Product Change Notification

Change Notification #: 0000019703-**01**
Change Title: Solidigm™ D5-P5316 Series (formerly Intel®) SKUs, Firmware/Label/Ordering Code, Rebranding Changes
Customer: Generic SKUs
Original Date of Publication: July 29, 2024
Date of Latest Revision **October 23, 2024**

Solidigm Branding, Label, MR4 Firmware, New MM#s, and Ordering Codes

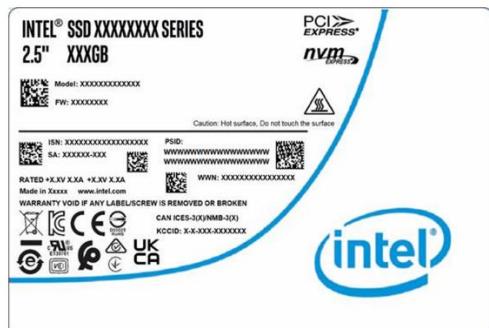
Solidigm is launching new Solidigm-branded D5-P5316 SSDs with the following changes versus the current Intel-branded SSDs (changes in **bold**):

Change	Before	After
Product Series Name	Intel® SSD D5-P5316 Series	Solidigm™ D5-P5316 Series
Logos and branding	Intel	Solidigm
New MM#s and Ordering Codes (Full list on pg. 3)	<u>MM#s:</u> 6-digit (ex: 99AA1N) <u>Ordering Codes:</u> Ending in "N1", "OS", or "10" (ex: SSDPF2NV153TZN1)	<u>MM#s:</u> 9-digit (ex: AA001986F) <u>Ordering Codes:</u> Ending in "1Z", "OZ", or "TZ" (ex: SSDPF2NV153TZ 1Z)
Firmware Version *Solidigm Ordering Codes only, no FW change for Intel-branded SSDs	Non-Opal: ACV10240 "PRQ1 MR3" Opal: ACV10340 "PRQ2 MR3"	Non-Opal/Opal: ACV10360 "MR4"
Vendor ID	0x8086	0x025e
Model String (MS)	INTEL SSDPFxNVxxxTZ	SOLIDIGM SSDPFxNVxxxTZ
Label	See pg. 2

U.2 15mm Drive Label

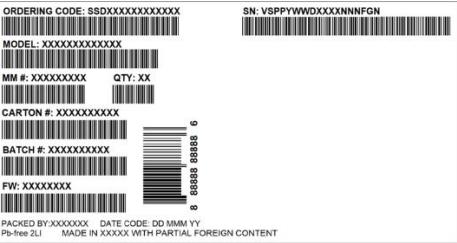
Present	Post-change
	 <p>Note: Opal displays PSID, Non-opal displays DUID</p>

U.2 15mm Box Labels

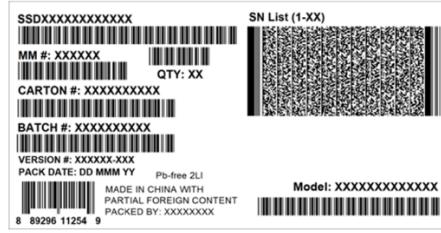
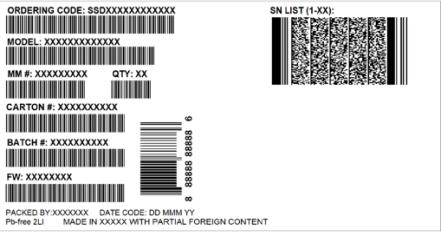
Present	Post-change
 Inner Box Label	 <p>Note: Removed UKCA logo and UKCA address</p>
 Outer Box Label	 <ul style="list-style-type: none"> Added Ordering Code human readable and barcode Added UPC barcode
